# TECHNICAL SERVICE INFORMATION BULLETIN

TSIB 15-01, rev B		November 4, 2015
<b>TO:</b>	All Operators	
<b>TITLE:</b>	Steering Damper Mount Inspection	
<b>APPLICABILITY:</b>	All New Flyer Xcelsior Buses

**Figure 1: Typical examples of acceptable (left) and unacceptable (right) steering damper installations**

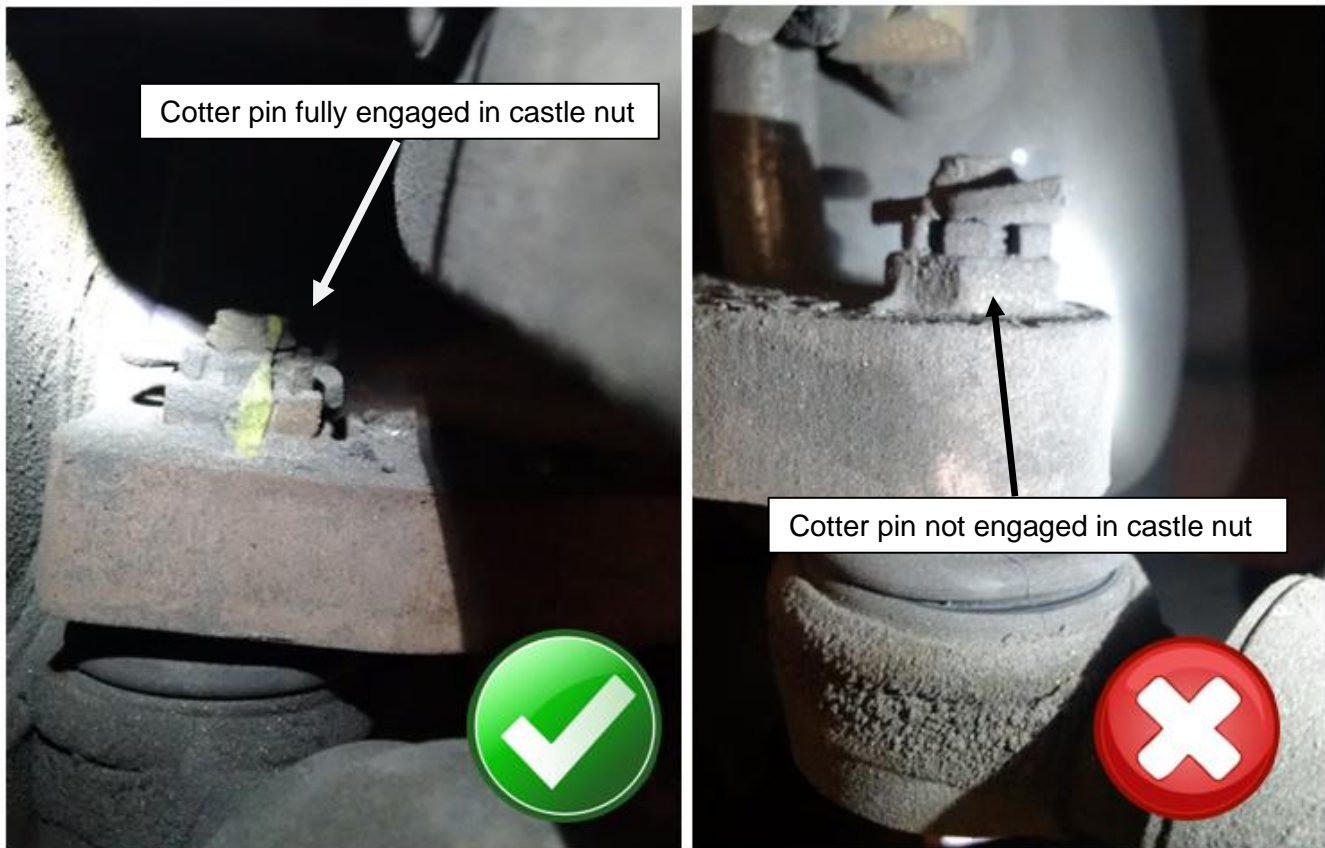
1. Raise the bus and locate the steering damper connecting the curb side front axle steering knuckle and the chassis.
2. Inspect the damper ball studs and both the frame and knuckle mounting plates:
  - Attempt to move the damper within the mounts using a pry bar.
  - Rotate the steering wheel several times through its full range of motion to look for free play between the damper and mounting plates.
  - The castle nut at both joints should be tight and the cotter pin should be fully engaged in the castle nut.
  - No relative motion between the damper ball stud and the mounting plate is permissible

Figure 1 demonstrates an acceptable installation on the left and a defective installation on the right.

Damper and Mount Condition	Recommended Action
No issue found	No action required. Apply a torque stripe to the castle nut if none is present.
Cotter pin is missing (No play between ball studs and mounts)	Torque castle nut to 55 ft-lbs dry and install cotter pin (NF P/N 6360402). Ensure cotter pin fully engages castle nut. Apply a torque stripe to the nut.
Cotter pin does not fully engage castle nut (No play between ball studs and mounts)	Remove and discard cotter pin. Install a washer (NF P/N 579798) between the castle nut and mount. Torque the castle nut to 55 ft-lbs dry. Install a new cotter pin (NF P/N 6360402). Ensure cotter pin fully engages castle nut. Apply a torque stripe to the nut.
Free play between the damper ball studs and mounting plates	Remove the existing affected mount and replace it with a new chassis-side (NF P/N 579980) or axle-side (NF P/N 583640) mount according to the instructions in the New Flyer Service Manual. Replace the damper, both castle nuts, and both cotter pins at this time.

Unattached steering damper joints (Ball joint stud completely separated from mount)	Remove the existing affected mount and replace it with a new chassis-side (NF P/N 579980) or axle-side (NF P/N 583640) mount according to the instructions in the New Flyer Service Manual. Replace the damper, both castle nuts, and both cotter pins at this time.
